APPENDIX B:
Alternative Concept Plans

ROUTE 41 AND ROUTE 841
ALTERNATIVE 5A

APPENDIX C:
Public Comments and Responses Document

Route 41 (Gap Newport Pike) and Route 841 (London Grove Road), Chester County, PA**PennDOT Engineering District 6-0****June 11, 2019 Open House Comment Response Document****Prepared October 18, 2019**

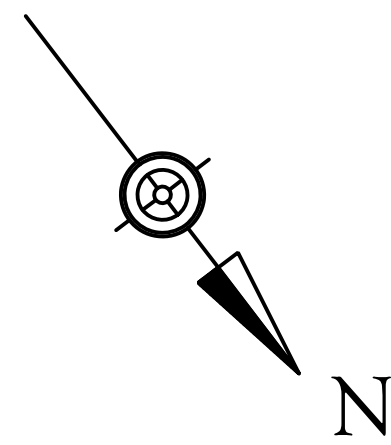
Comment #11: Alternative 5A impacts residences and is more difficult for E. London Grove traffic wanting to travel south on Route 41. Alternatives 6 and 10 have serious impacts and require using a stop sign to cross Route 41. Alternative 9 is the worst of all with little positive to

Comment #16: I am concerned that Alternative 5A will have the psychological effect splitting off the eastern section of Chatham from the rest of the village, a problem that 5B will minimize.

Comment #18: Although 5A and 5B appear similar I believe there is a large difference in the way they will be perceived and accepted by the local community: Coming from East London Grove Road, with the roundabout near at hand (as with 5B), and going south, southwest, or west, a driver will face a minor inconvenience. But with the roundabout, an additional one hundred feet north on PA41 (as with 5A), the same maneuver will present an ongoing frustration.

PennDOT Response #11: Since the public meeting, Alternatives 9 and 10 have been dismissed from further study. The remaining alternatives (Alternative 5a, 5b, and 6) do not impact the Chatham Hotel building.

PennDOT Response #16: Community cohesion is a consideration and will be taken into account as Alternatives 5a, 5b and 6 are progressed through design.

PennDOT Response #18: Since the public meeting, PennDOT has dismissed Alternatives 9 and 10. Alternatives 5a, 5b, and 6 will be carried forward. The concerns you describe in your comment will be evaluated as the alternatives continue to be refined.

ROUTE 41 AND ROUTE 841
ALTERNATIVE 6A*

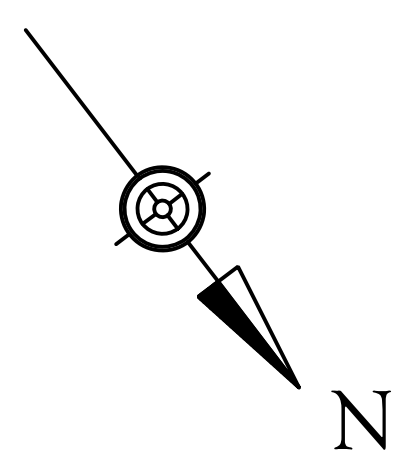
Comment #6: Option #6 would be nice if it used a roundabout. Would also like to see a roundabout incorporated into Option #10.

PennDOT Response #6: Since the public meeting, both Alternative 6 and Alternative 10 were studied as roundabouts at these locations. Alternative 6 as a roundabout satisfies all of the project needs and will be carried forward into further study. However, Alternative 10 only provides partial improvement and does not fully satisfy the project needs. Alternative 10 was dismissed from further study.
